Vehicle Owner Notification

Subject: VON # 83- Blown Fuse with 100% DRL Low Beam

VEHICLE OWNER NOTIFICATION #83

MODEL: EFX
SUBJECT: BLOWN FUSE WITH 100% DRL LOW BEAM
PAGE: 1 OF 3

—Figure 1

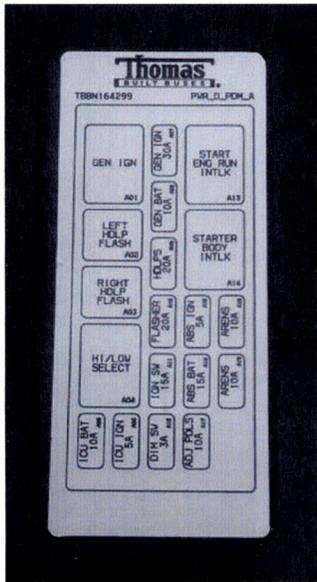
Some EFX School Buses built between January 2, 2012 to October 4, 2012 ordered with option C3676-24-000 may pop breaker to the headlamps after about 45 minutes causing all headlamps, marker, and cluster lamps to shut off. If these conditions exist, this is the only time breaker should be replaced with 30A Type 1 breaker.

LOCATION OF BREAKER
IF 20A IS PRESENT, REPLACE WITH
30A BREAKER.

4. Remove 20A breaker retain for future use.
5. Install new 30A Type I breaker #TBB 159393 purchased from PDC (only type that is approved).
6. Locate the cover to the PDM that you removed. It should have a label on it telling where each breaker and relay goes in the PDM. **Figure 2**
7. Clean dust and other debris off of the original label for PDM
8. After it is clean, take #TBB 181070 (purchased from PDC) and apply directly over the original label. **Figure 3**
9. Reinstall cover and verify operation of lights.
10. Remove Chocks when done.
